**TOWN OF PORTOLA VALLEY
ARCHITECTURAL AND SITE CONTROL COMMISSION (ASCC)
Monday, August 25, 2014
Special Field Meeting (time and place as listed herein)
7:30 PM – Regular ASCC Meeting
Historic Schoolhouse
765 Portola Road, Portola Valley, CA 94028**

TO: ASCC
FROM: Karen Kristiansson, Deputy Town Planner
Carol Borck, Assistant Planner
DATE: August 22, 2014
RE: Agenda for August 25, 2014 ASCC Meeting

RE: Architectural Review for Modifications to a Previously Approved Detached Guest House and Detached Studio, 465 Golden Oak Drive, Hicks

1 PROPOSED STUDIO

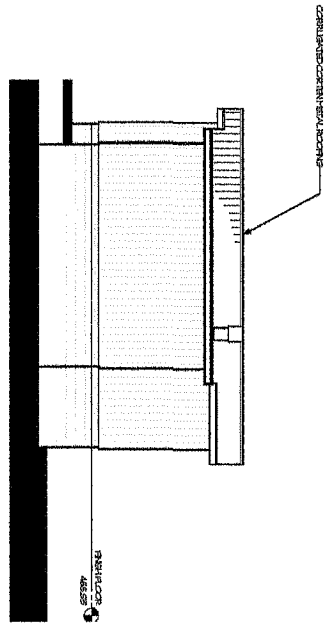
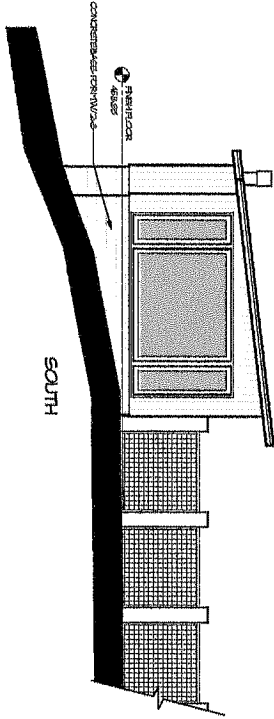
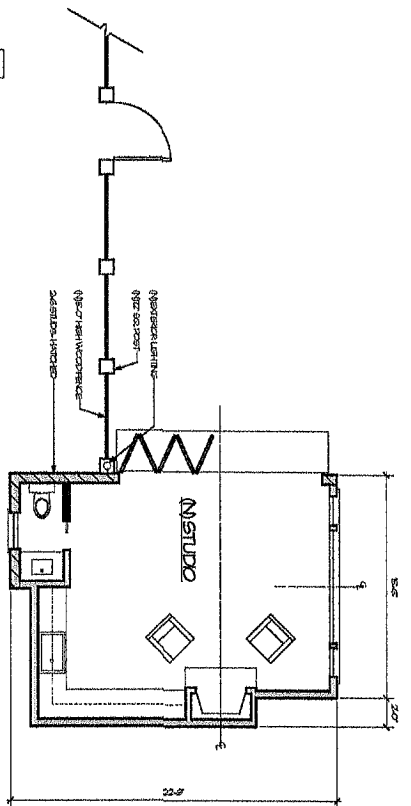
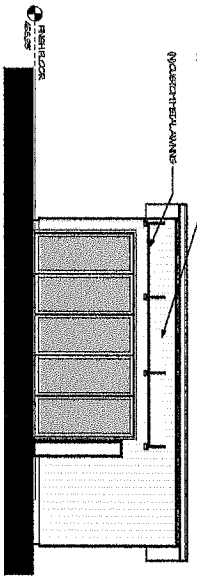
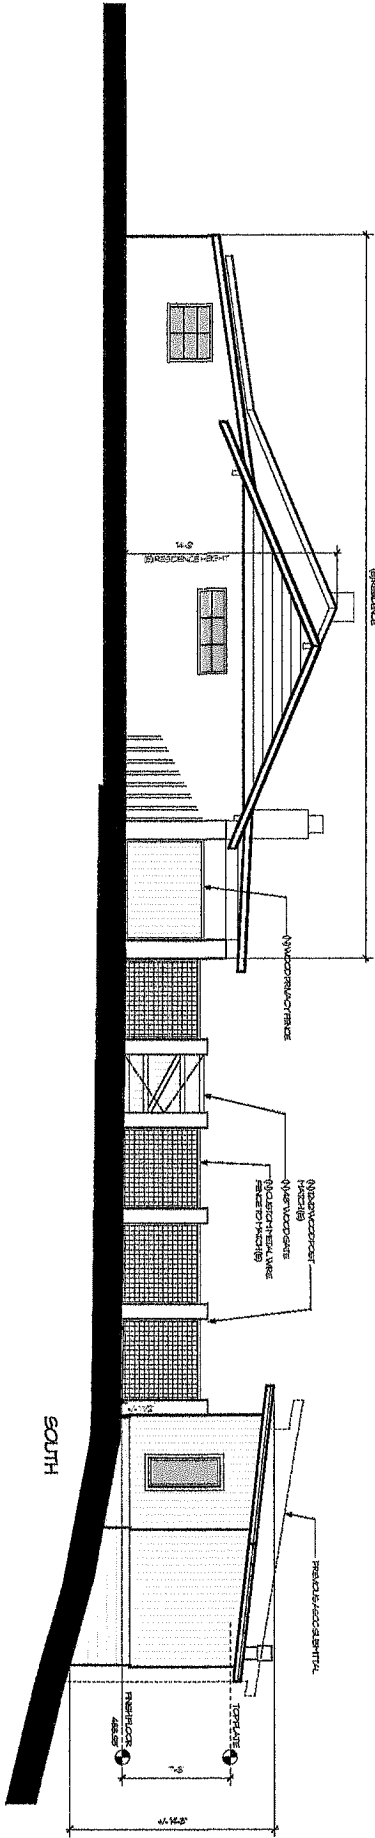
Sheet A3 shows elimination of the east elevation window.

As was discussed for condition #4 above, the purpose of these two conditions was to reduce the apparent height and mass of the studio when viewed from off-site in order to better comply with the Town's Design Guidelines. In response, a number of changes have been made to the studio design:

As shown on Sheet A3, the proposed downlights on the pedestrian gate have been eliminated.

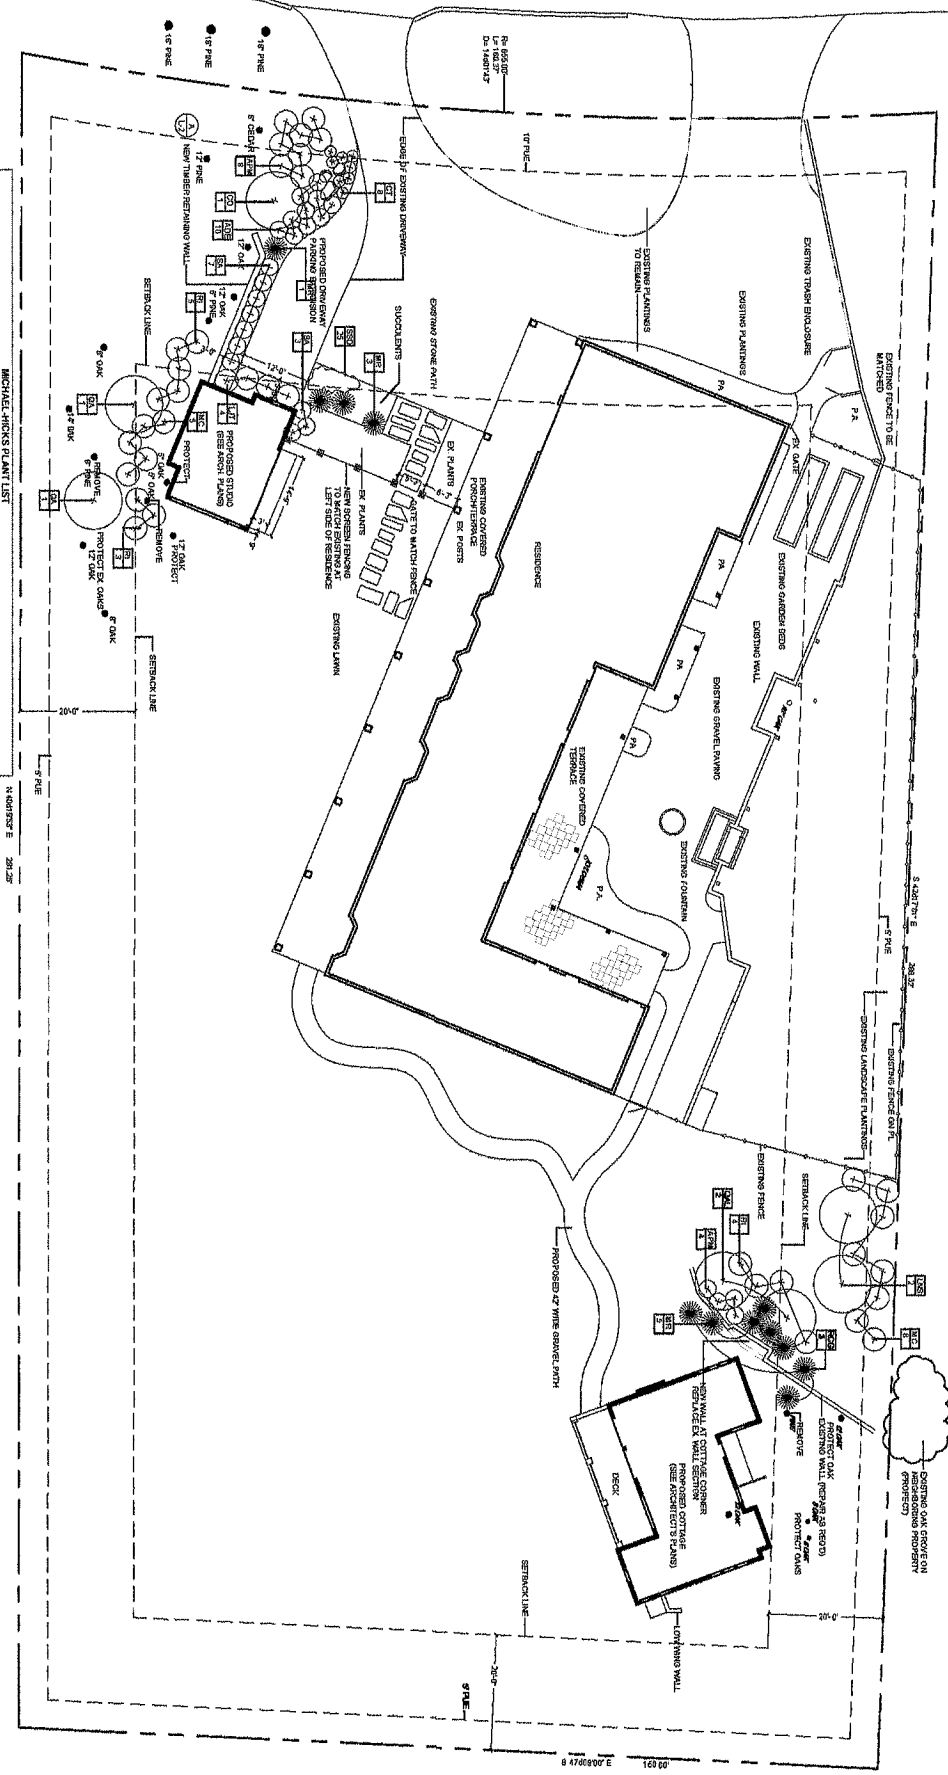
Landscape screening for the studio has been modified as shown on Sheet L1. In addition to preserving one of the five-inch oaks which was originally proposed for removal, two additional 24" box live oaks are proposed to be planted on the eastern elevation.

The proposed plant palette includes plants which are not listed on the Town's native and supplemental plant lists, including Sweet Bays, Pacific Wax Myrtles, Wax Leaf Privet, Needle Grass, Two Row Stone Crop, Brown Sedge, and Deer Grass. Of these, the Pacific Wax Myrtles and the Deer Grass appear to be native to California, while the Wax Leaf Privet may be invasive. The other plants appear to be non-native ornamentals which are not generally considered invasive.

The proposed screening plan is shown on Sheet L1. The plantings along the fence area include two 24" box Sweet Bays and eight Pacific Wax Myrtles. Additional plantings are proposed closer to the guest house. The grapevines are no longer included in the plan. At the time of staff report preparation, the uphill neighbor at 455 Golden Oak Drive was in the process of reviewing the plans with the applicant.

REVISED GRADING PLAN

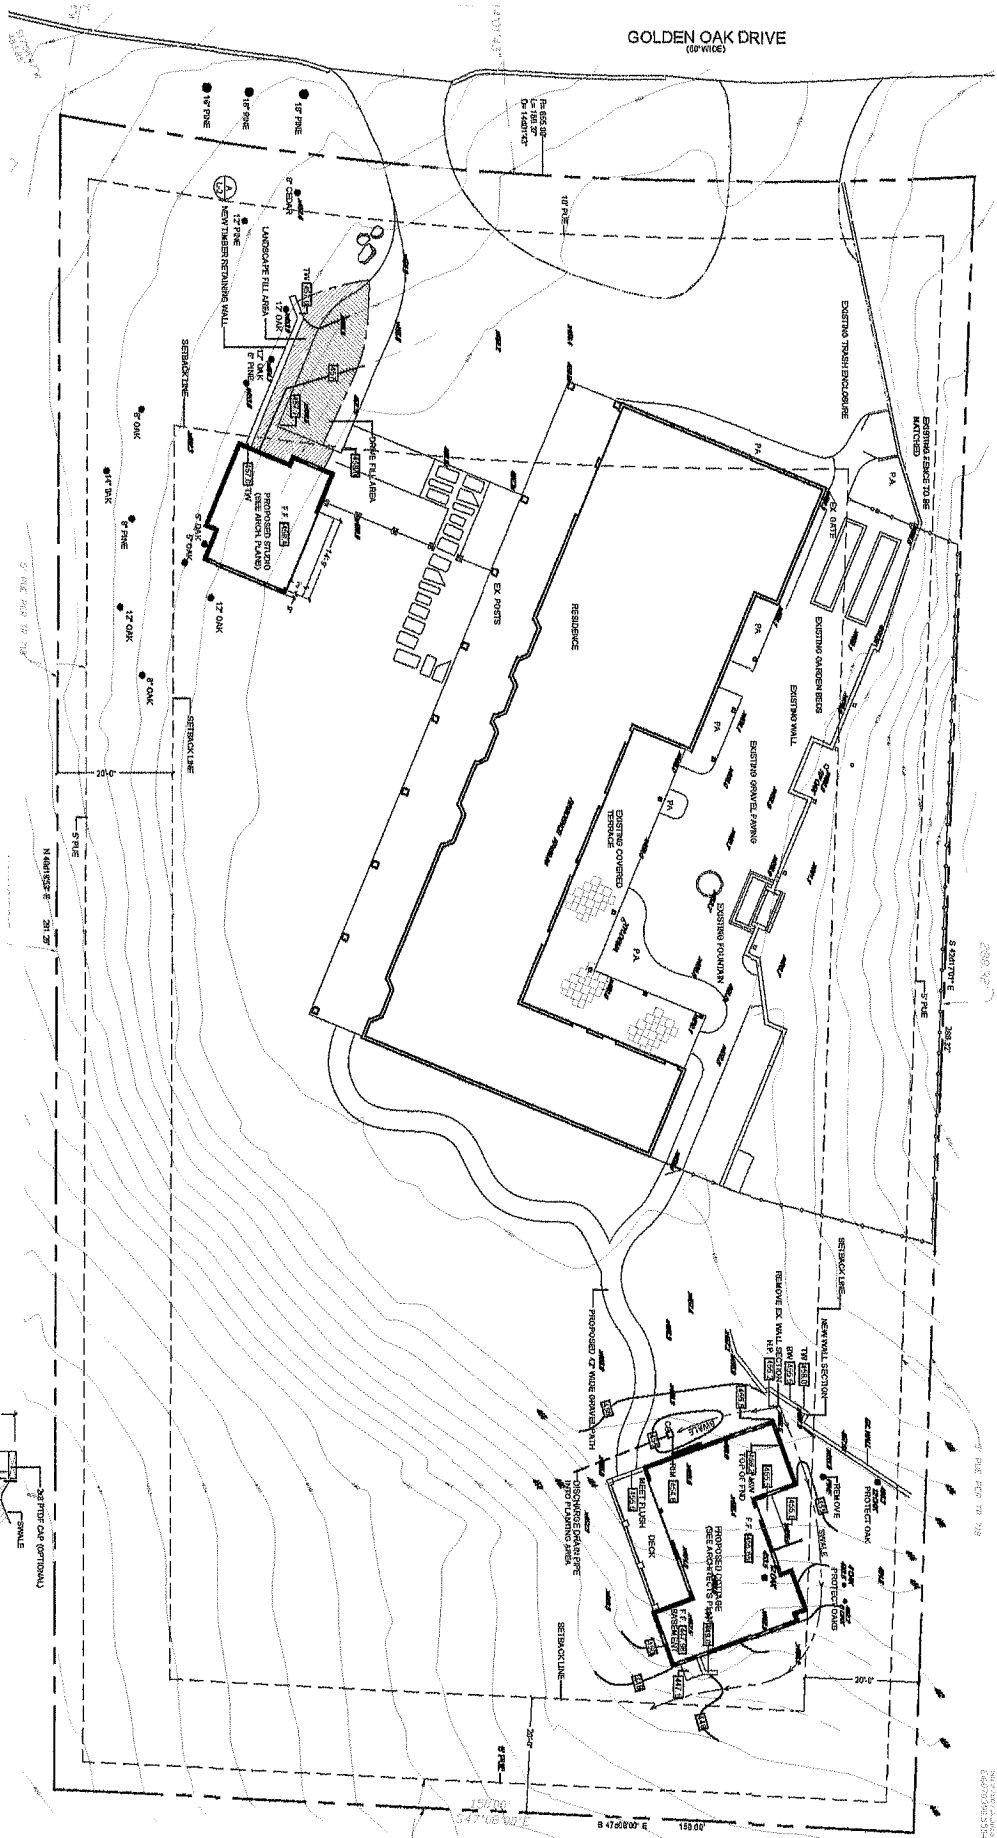
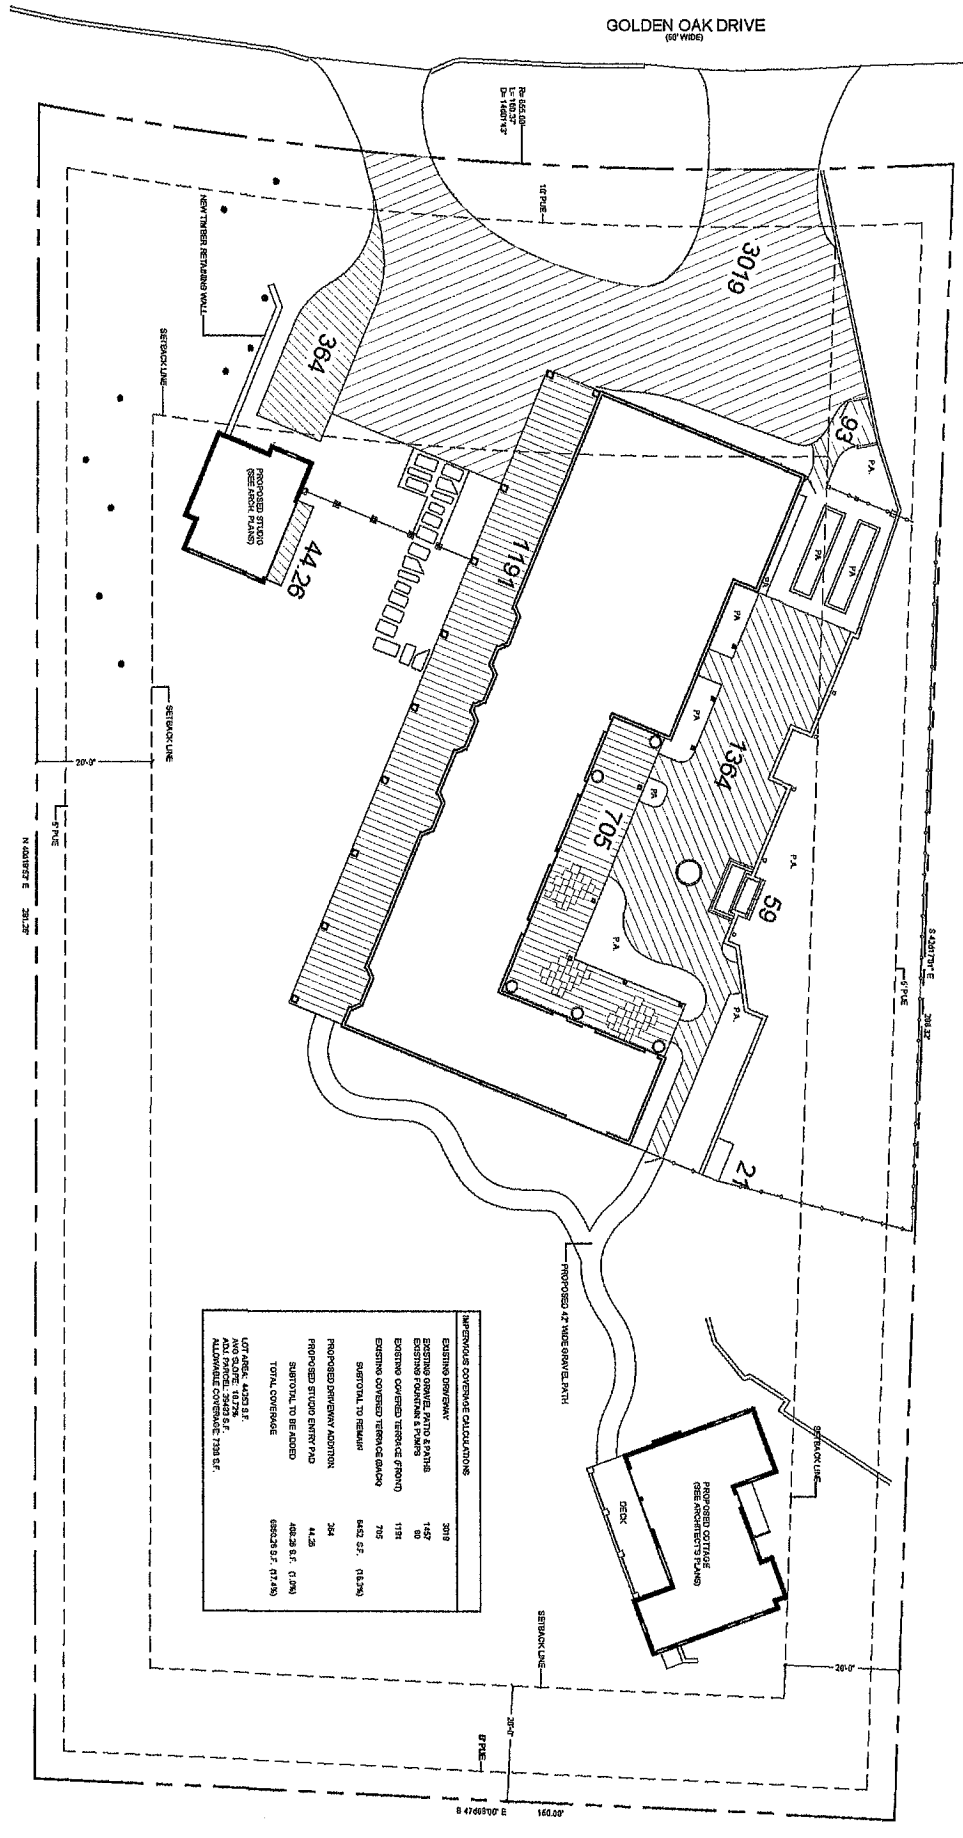
The guest house has been lowered by one foot, and grading around the guest house has been adjusted accordingly. In order to better integrate the guest house into the site, the project team has agreed to maintain the existing grade along the east elevation by installing a low retaining wall. Another low retaining wall will be used along the north elevation. The revised Sheet A2, which is stamped received on August 21, 2014 and provided as a separate 11" x 17" sheet, shows the proposed guest house elevations with the grading changes. Minor changes to the grading plan will be needed prior to building permit issuance for consistency.
